Stellaris® LM3S9B92 RevB1 Errata

This document contains known errata at the time of publication for the Stellaris® LM3S9B92 microcontroller. The table below summarizes the errata and lists the affected revisions. See the data sheet for more details.

Figure 1. Timing Differences Between Rev B and Rev C Devices

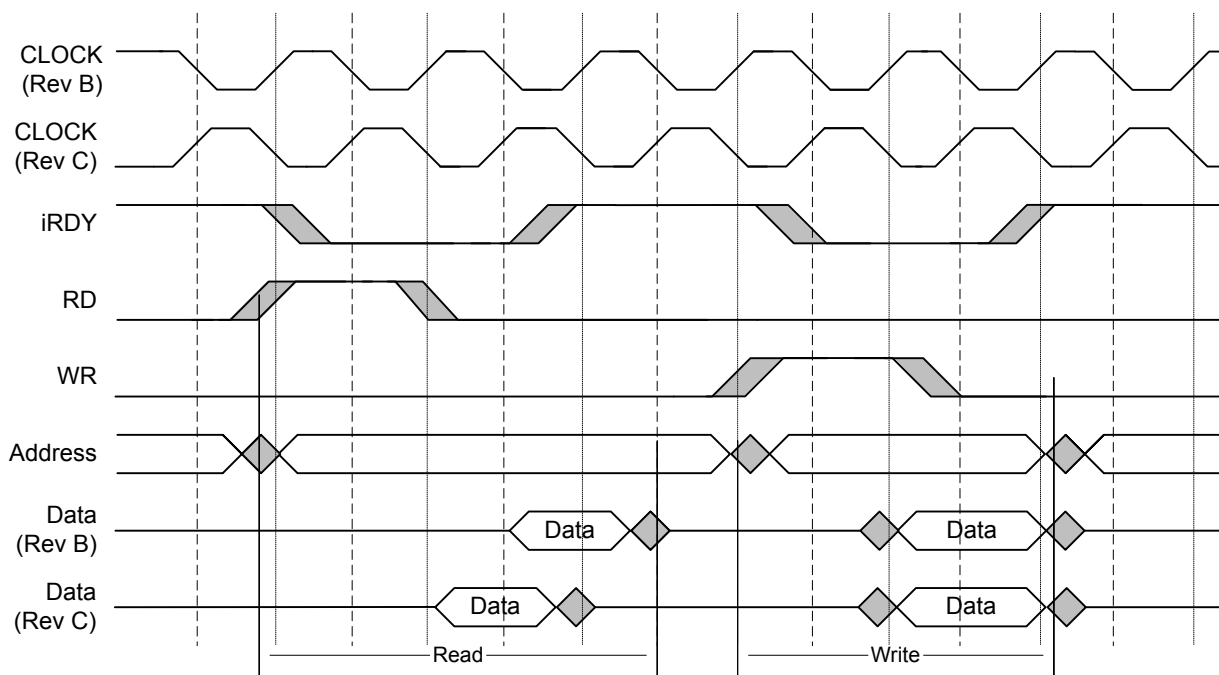
The clock signal that is output on the EPIO31 signal in General-Purpose mode is inverted. Figure 1 on page 13 shows the timing differences between Rev B parts and Rev C parts.

Use the opposite edge for timing when designing with this interface. During read cycles, ensure that the data meets set up and hold times for the appropriate edge as shown in the diagram above.

Figure 2. Recommended Center-Tap Connections

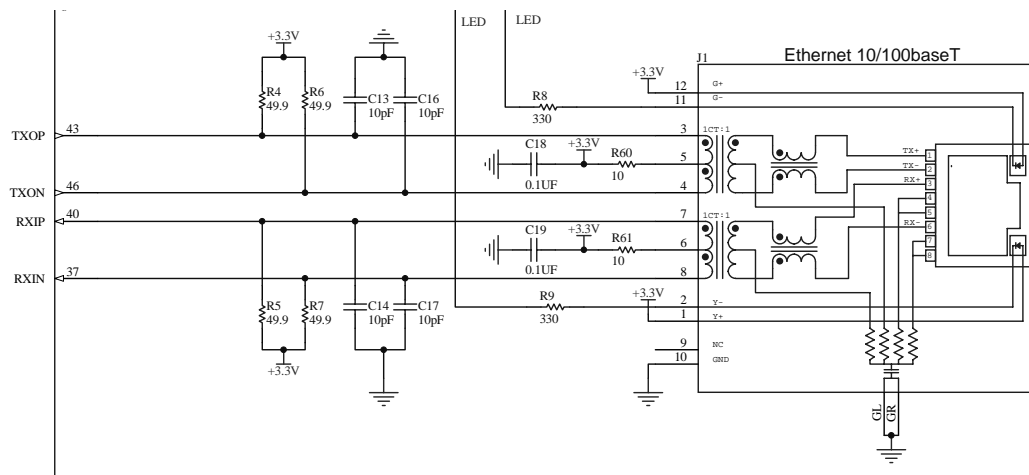
The microcontroller experiences some packet loss with Ethernet cables longer than 50 meters in normal operating conditions.

1. Add 10 Ω resistor to the center-tap of the transformer as shown in the figure. These resistors should be replaced by a direct connection for silicon that has this item fixed.
2. Continue using the recommended circuit, but limit cable lengths to 50 meters.

Figure 7. Configuration of External Regulator

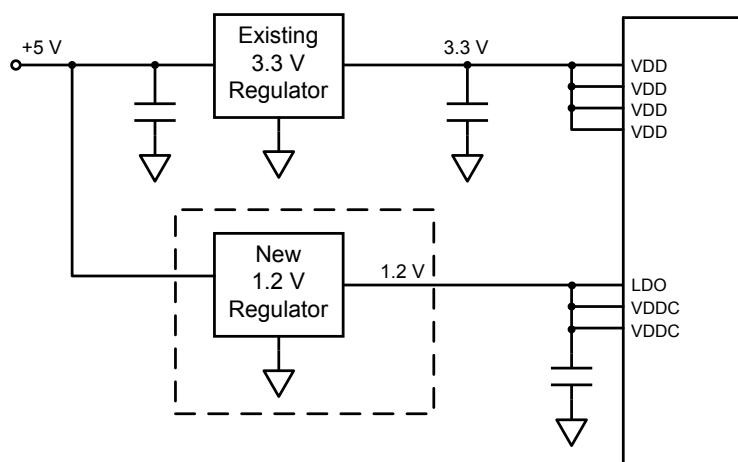
Incorrect power sequencing during power up can disrupt operation and potentially cause device failure.

V_{DDC} must be applied approximately 50 μs before V_{DD} . Normally V_{DDC} is controlled by the part's internal LDO voltage regulator. The workaround requires the addition of an external regulator (see Figure 7) to ensure that V_{DDC} sequencing requirements are met (see Figure 8). A recommended regulator is the TI TPS73101DBVR.
